Executive Director's Recommendation

PROJECT National Native American Veterans Memorial National Museum of the American Indian Independence Avenue and Fourth Street, SW Washington, DC	NCPC FILE NUMBER 8018
SUBMITTED BY Smithsonian Institution	NCPC MAP FILE NUMBER 1.71(73.10)45010
REVIEW AUTHORITY Pub. L. No. 103-384, §3 (c)(2), 108 Stat. 4067, 4068 (October 22, 1994), as amended and 40 U.S.C. § 8722(b)(1) and (d)	APPLICANT'S REQUEST Approval of final site development plans
	PROPOSED ACTION Approve final site development plans
	ACTION ITEM TYPE Consent Calendar

National Native American Veterans Memorial

Approval of Final Site Development Plans

Tree Preservation Plan

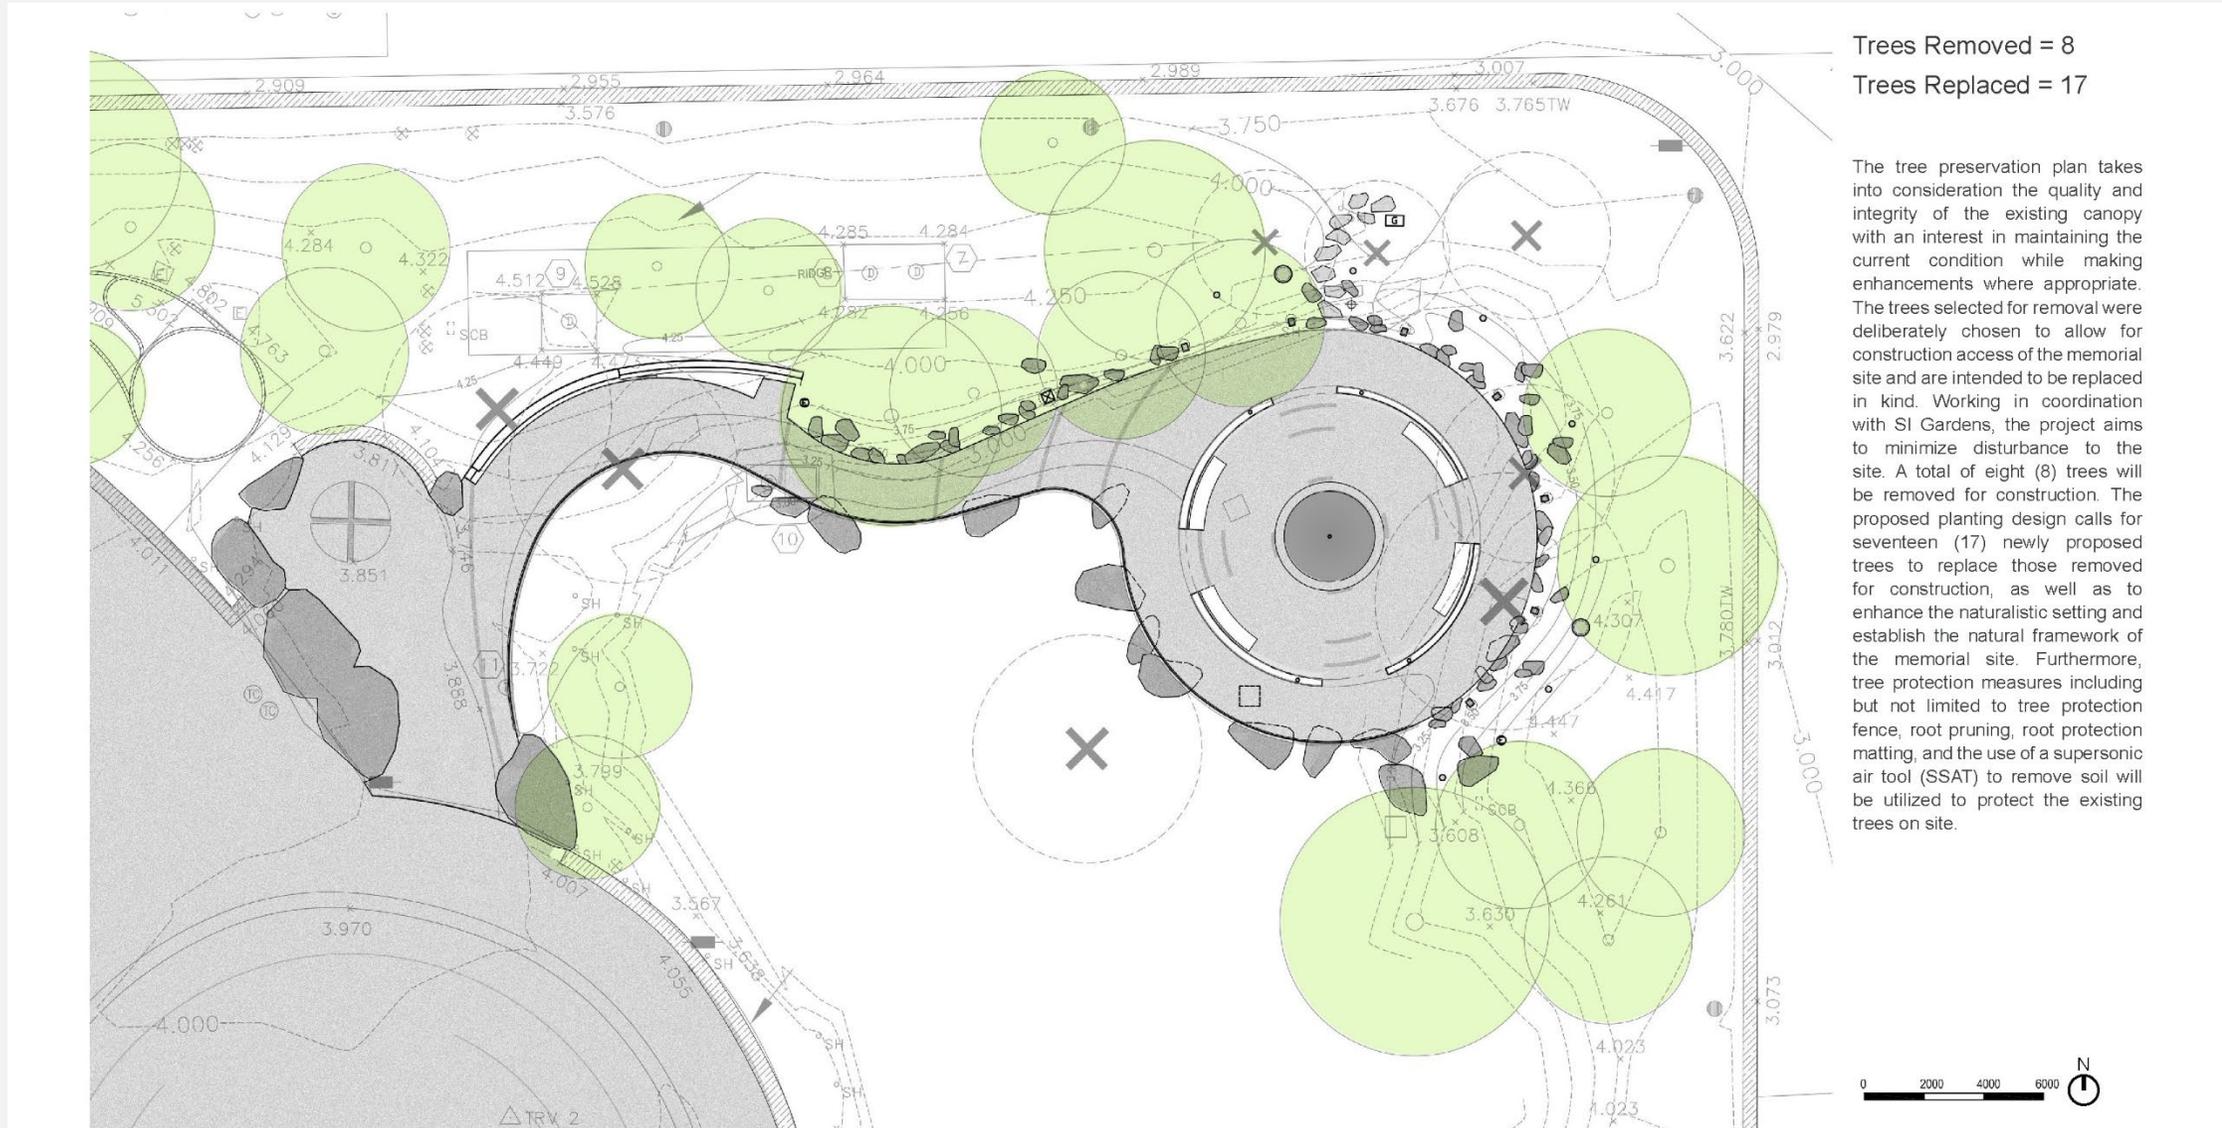
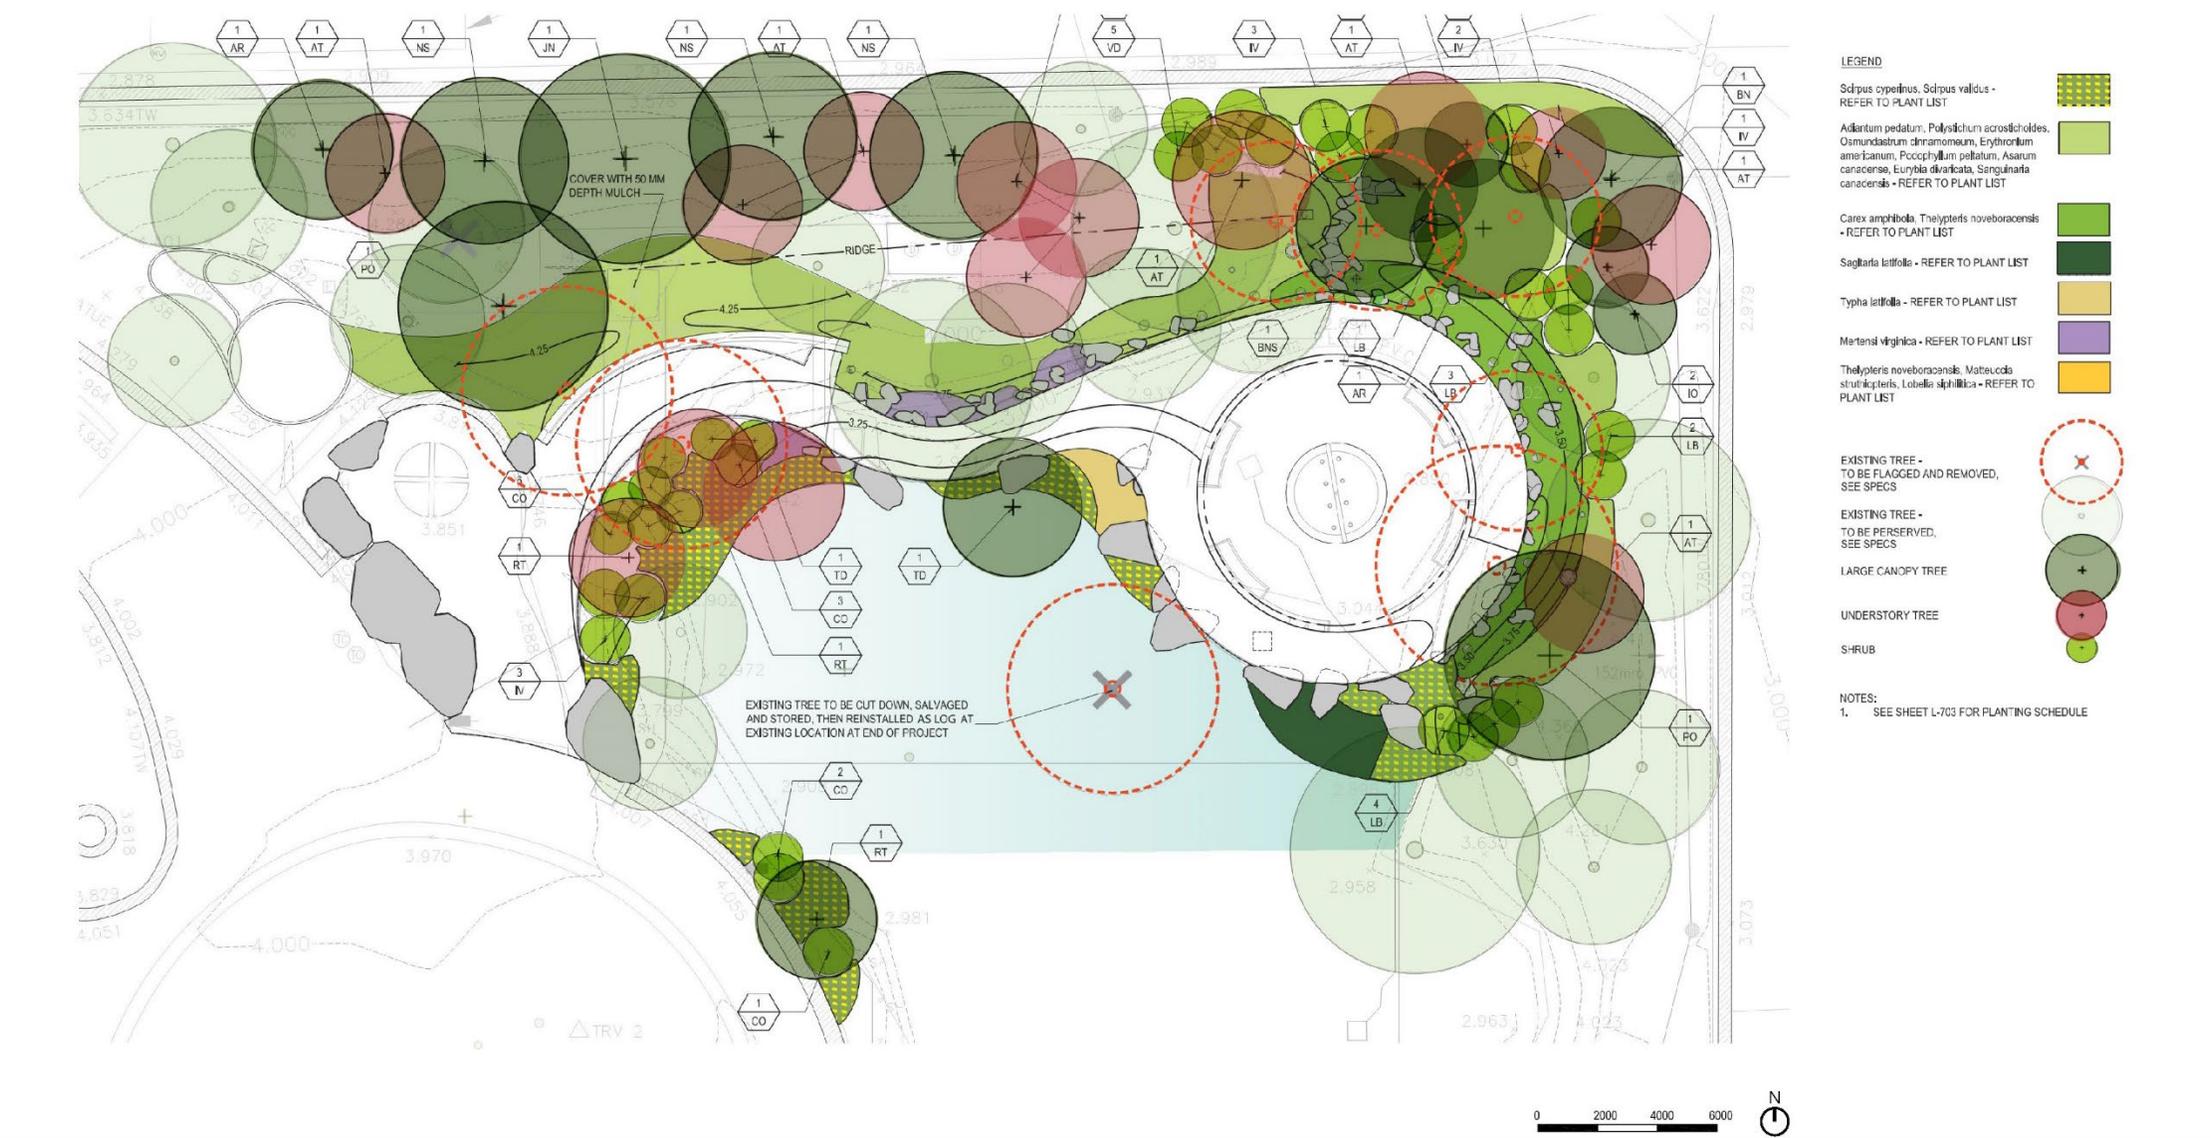
Previously, the Commission requested the applicant provide a landscape plan that includes tree replacement to prevent net loss of tree canopy in accordance with the procedures established in the policies related to Tree Canopy and Vegetation in the Comprehensive Plan for the National Capital. The requested landscape plan and tree protection plan have been provided, including the tree replacement to prevent a net loss of tree canopy on the site. To mitigate the removal of eight trees at the memorial site for construction, the Smithsonian will plant seventeen new trees nearby. The Smithsonian will also remove and replant four trees at the new bio-retention area, described in the following section. Overall, staff finds the landscape plan will adequately mitigate the loss of trees and will help preserve the character of the site.

Trees Removed = 4
Trees Replaced = 4

Proposed Lighting Plan

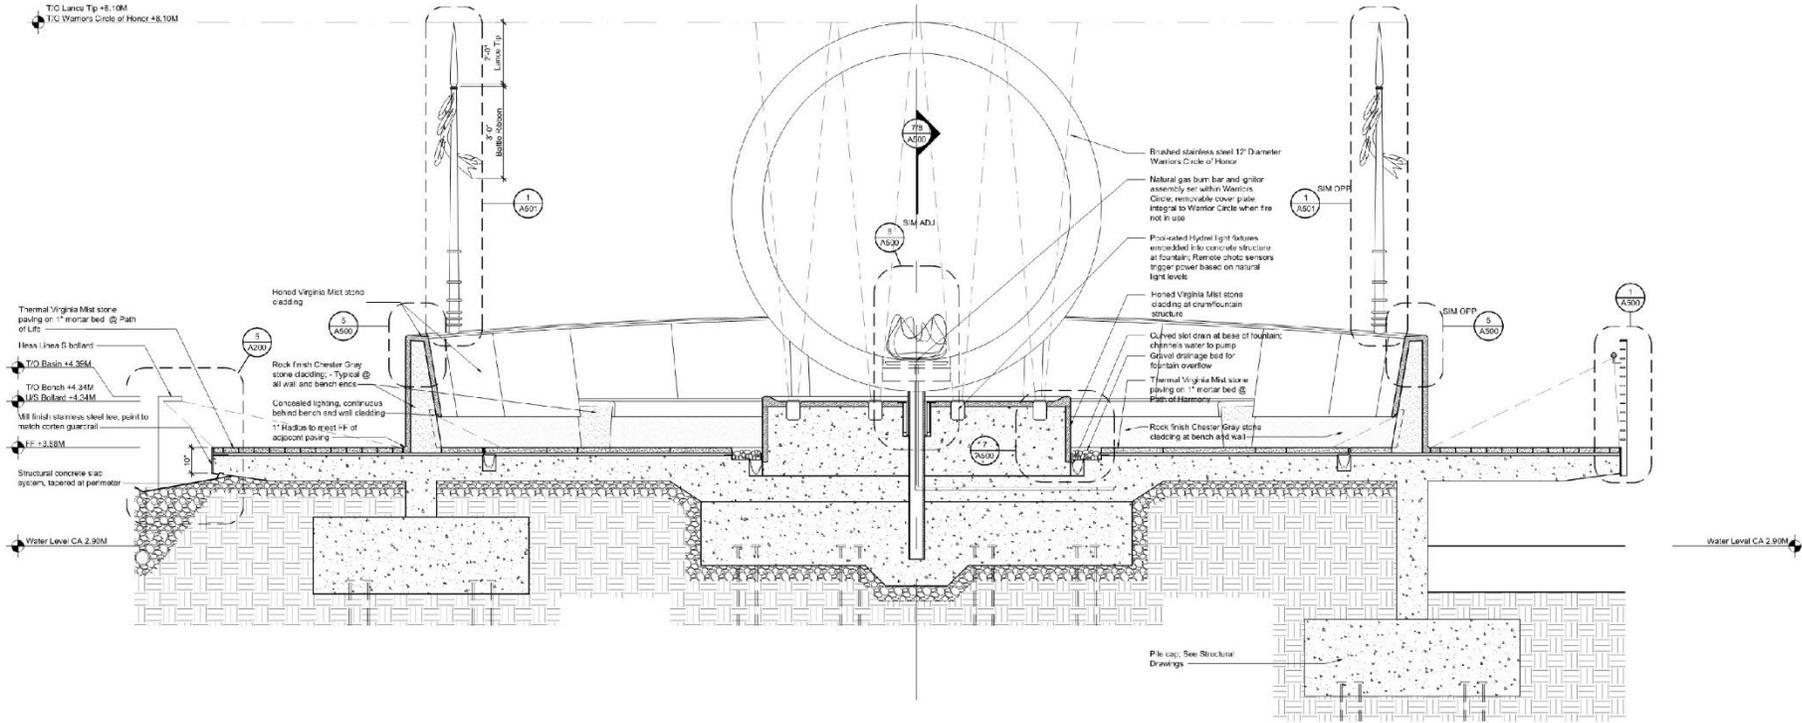
Finally, at preliminary review, the Commission requested the Smithsonian provide a lighting plan and night views consistent with the overall lighting design for the National Museum of the American Indian. They requested the lighting plan minimize light pollution and respect the hierarchy of memorials, monuments, and important civic buildings and spaces in the nation's capital, with the U.S. Capitol the most prominent feature in the nighttime skyline. In general, the lighting design approach provides adequate lighting for egress while providing minimal lighting for the Warrior's Circle and memorial elements. Staff finds the lighting plan is consistent with the

The lighting design approach for the memorial is to provide adequate lighting for egress while providing minimal lighting of the Warriors' Circle and accenting its design elements. The lighting plan for the memorial is consistent with the overall lighting design for the National Museum of the American Indian (NMAI). The lighting approach minimizes light pollution while respecting the hierarchy of other memorials, monuments, and important civic buildings on the National Mall.

The lighting of the memorial meets the NFPA 101 regulation. As such, illumination is not less than an average of 1 ft-candle (10.8 lux) and, at any point, not less than 0.1 ft-candle (1.1 lux), measured along the path of egress at floor level.

Railing Details

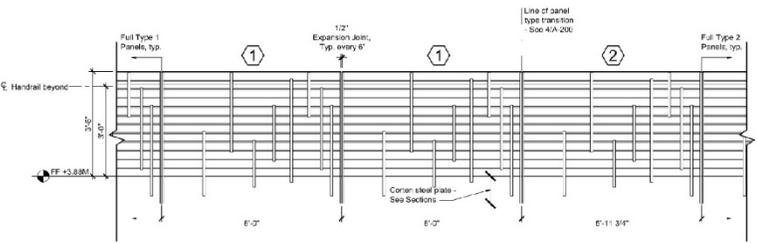
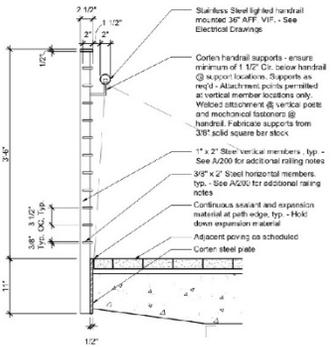
Previously, the Commission recommended the applicant simplify the railing design to minimize visual impacts, finding its heavy composition competed with the memorial elements, landscape, and the museum's architecture. The railing also appeared dense and overly busy. In response, the design team has revised the railing design to simplify the elements. Further, the railing sizes have been reduced in both thickness and width. The vertical members of the railing are now standardized and have rhythmic spacing, including a continuous vertical member to accommodate wiring for the handrail lighting. Vegetation at the edge of the railing has been revised accordingly to provide a softer backdrop. The railing material is proposed to be corten steel which has a natural finish that will blend into the landscape. Overall, staff finds the design has been simplified while still accommodating the designers' intention of creating a rhythmic element that connects to the memorial, in balance with code requirements. SI has indicated that they will prepare a full-scale mock-up which staff will be able to see during the construction period. SI believes the design is appropriate to the setting and also reflects the design intent of the memorial experience.

In their review, the Commission members commended the project team for its responsiveness to their previous comments and for sensitively integrating the new memorial into the existing wetland landscape. However, they commented that the railing proposed along the path bordering the water appears dark, heavy, and reminiscent of a cage—potentially imposing a sense of separation instead of connection between visitors and the lush, elegant landscape. While they recognized the need for a safety barrier along the water's edge, they recommended making the railing appear lighter and more transparent, perhaps through reducing the number and thickness of its components, or even lowering or eliminating it at locations as allowable by safety regulations. They supported the overall hierarchy of metal materials proposed, including the use of CorTen steel for the railing in contrast to the stainless steel of the memorial's honorific elements such as the central sculpture, the Warriors' Circle of Honor. In general, they requested a more recessive and open treatment for this barrier, whether by reducing its scope and extent, minimizing its apparent density, or adding lighting to the background vegetation. They characterized the design of the paving as elegant throughout the length of the winding walkway and within the memorial circle, but awkwardly unresolved at the location where these two treatments meet; they recommended refining this detail, possibly using paving stones of varying widths so that the walk appears to feather into the circle. Finally, they suggested considering the effects of climate change in the specification of plant materials and the long-term viability of particular species.

The project includes a protective guardrail at the southern edge of the Approach Walk. The railing is required due to the adjacent water and the height of the walkway above the wetland. The railing system is composed of horizontal corten rails and secondary vertical members that are evocative of a drumbeat emanating from the memorial core. A stainless handrail will be mounted at 36 inches in height. An intermittent path lighting will be integrated into the railing. The railing will be 42 inches in height to meet code requirements.
